Docket Number:	19-AB-2127
Project Title:	Implementation of AB 2127 Electric Vehicle Charging Infrastructure Assessments
TN #:	236917
Document Title:	TURN Comments on AB 2127 Report
Description:	N/A
Filer:	System
Organization:	Eric Borden
Submitter Role:	Intervenor
Submission Date:	2/26/2021 10:42:52 AM
Docketed Date:	2/26/2021

TURN Comments on AB 2127 Report

**COMMENTS OF THE UTILITY REFORM NETWORK ON THE CALIFORNIA
ENERGY COMMISSION'S AB 2127 REPORT**

DATE: February 26, 2021

Figure 1. Example of Sensitivities to Provide Greater Transparency to Key Assumptions in AB 2127 Report

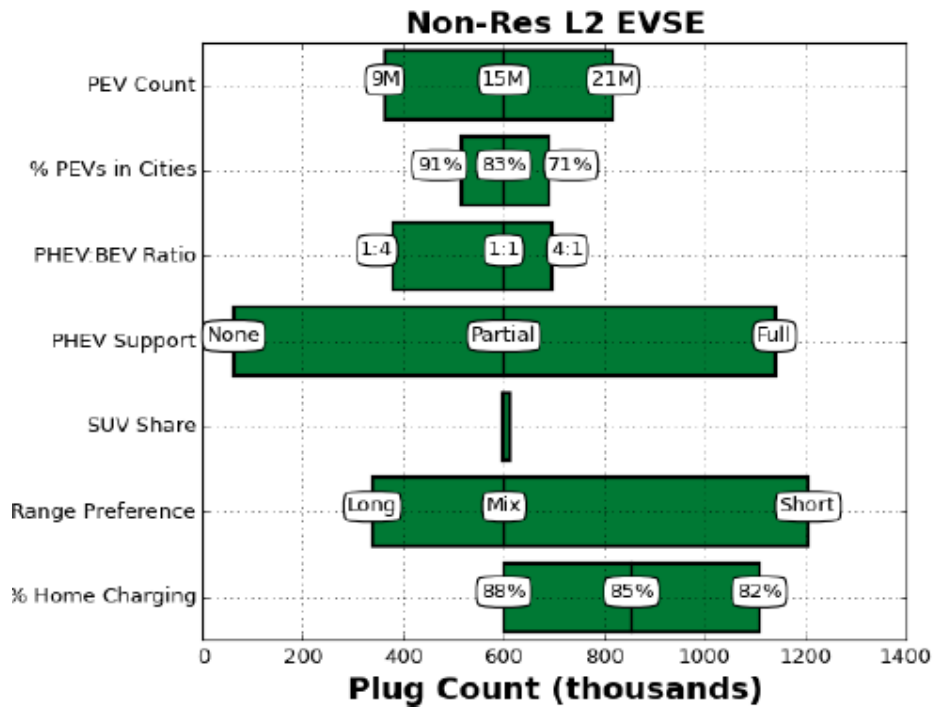
In addition to adding further sensitivities to aid the public in understanding a wider range of possibilities, discussed below, TURN recommends the report include a discussion and figure akin to the National Renewable Energy Laboratory’s 2017 initial report on EV charging assessment needs; based on similar modeling efforts, the report included the following figure which illustrates the range of outcomes for the primary assumptions that drive charging ports needed:

This additional transparency will aid stakeholders and decisionmakers in their understanding of the complex modeling behind the CEC’s analysis, as well as the range of results possible using reasonable assumptions.

Figure 2 Estimated and Observed Attach Rates vs. CEC Average Result
Ports per 1000 Electric Vehicles
L2 Non-Residential Charging⁷

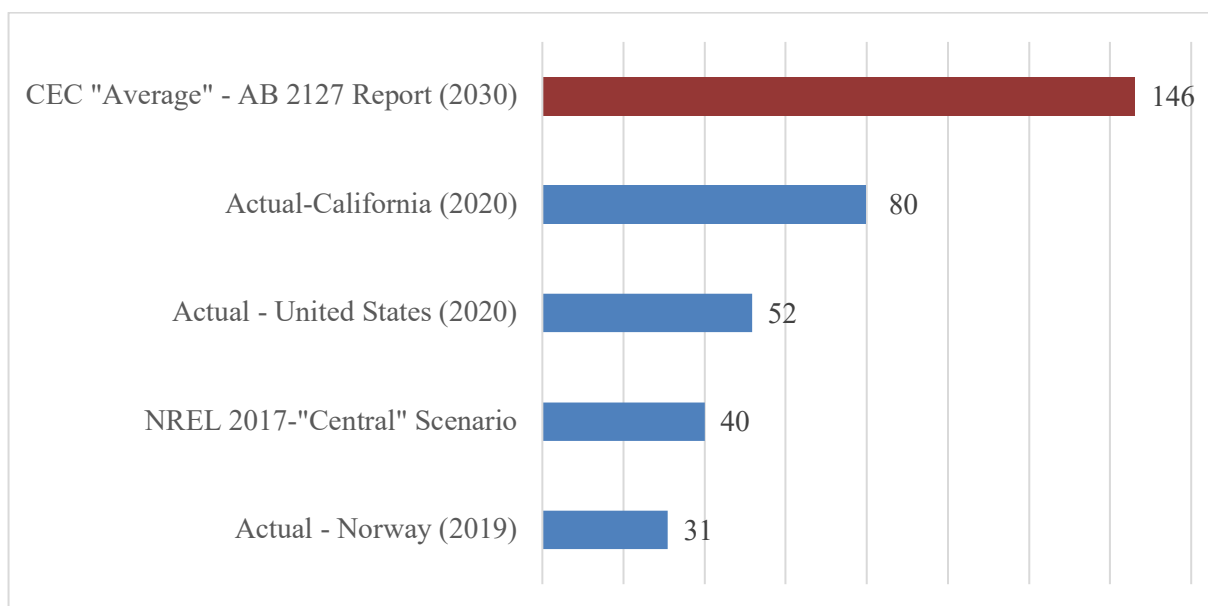
The CEC’s modeling results to determine the “needed” number of ports do not seem to represent true “low” or “average” scenarios; indeed the CEC’s analysis finds “attach rates,” or ports “needed” per electric vehicle that are *significantly higher than actual attach rates* observed in California and other locales for level 2 non-residential stations, as well as previous modeling that used substantially similar methodologies as the CEC’s analysis.

For purposes of these comments, TURN did not analyze other port needs (e.g. DCFC) though they may contain similarly conservative (high) assumptions. Though we acknowledge imperfect data is available for the comparison provided above, we have done our best to provide what should serve as a reality check on the “average” presented in the CEC’s analysis. Indeed, the Figure above shows that EV adoption to-date has occurred at substantially lower “attach rates” than assumed by the CEC as “necessary” by 2030, even if one assumes higher number of chargers than shown in the figure.

Figure 3. Estimated Housing Units in 2030 with Access to Residential Charging⁸

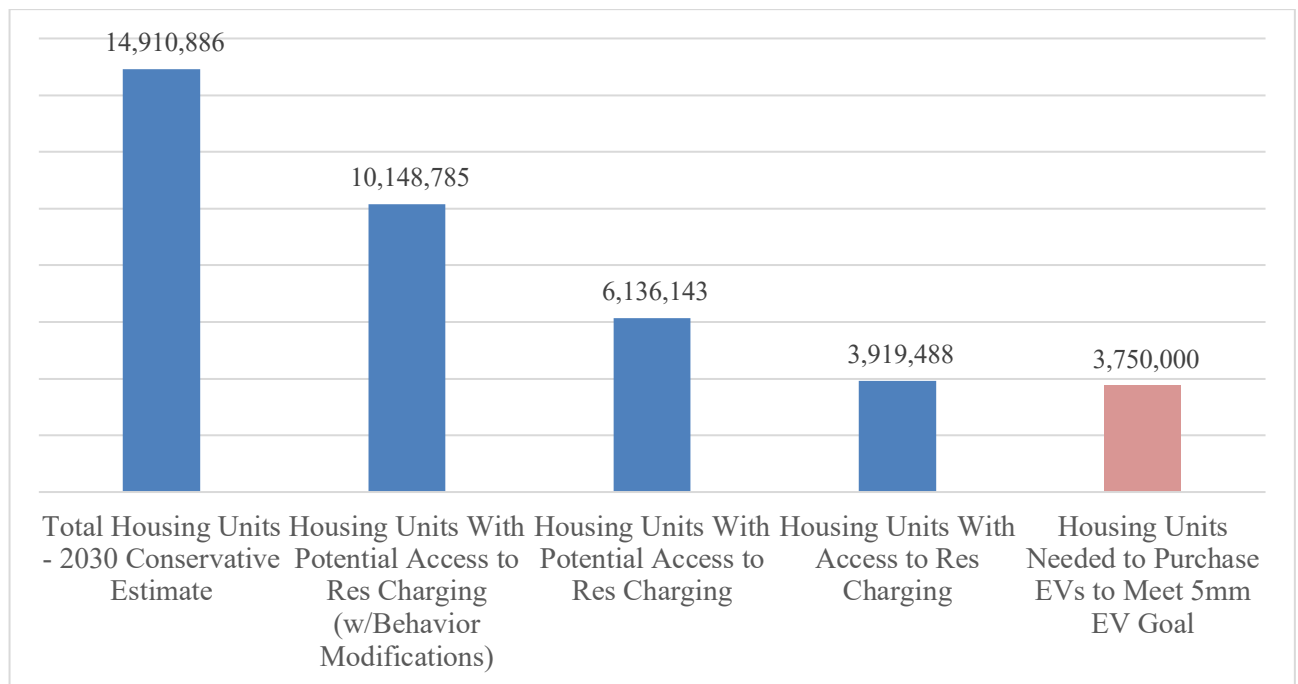
There are likely numerous assumptions driving the CEC’s high estimates, which alone may not necessarily be unreasonable, but together, may be leading to unnecessarily high estimates of the need for non-residential charging. Based on TURN’s current understanding, one of the factors that may be driving high results is that the CEC assumes large-scale adoption of EVs for residences who do not have access to residential charging. First, it is unclear today whether consumers will adopt EVs on a large scale without access to residential charging, even with lots of public chargers – this is one reason why TURN has been a staunch advocate for smart ratepayer spending on charging stations to be deployed at or near multi-unit dwellings (MuDs). But significantly, California’s current EV goals can easily be met by households who have access to residential charging, or who with “behavioral modifications” – meaning parking near existing outlets or changing parking behavior overnight- can have access.

The CEC should consider in its scenarios whether it is better and more efficient public policy to spend billions of dollars on an excessive number of public chargers or provide greater education to homeowners and renters of existing residential charging opportunities, in addition to opportunities to install smart charging. Based on adoption trends to-date that find consumers value the ease and convenience of residential charging,⁹ not to mention the fact that the pandemic will likely accelerate the work-from-home trend and may therefore decrease reliance on workplace charging, greater reliance on residential charging is more likely to be a successful strategy to drive the market rather than hoping a large number of public chargers will result in meeting EV adoption goals. Further, income-based subsidies to ensure residential access to overnight charging would likely be more cost-effective than a massive buildout of potentially low-utilized public charging stations. These statements should not at all minimize the importance of well-placed and highly-utilized public and private (shared) charging infrastructure – as in most problems we confront in energy policy, there will be no “one size fits all” solution.
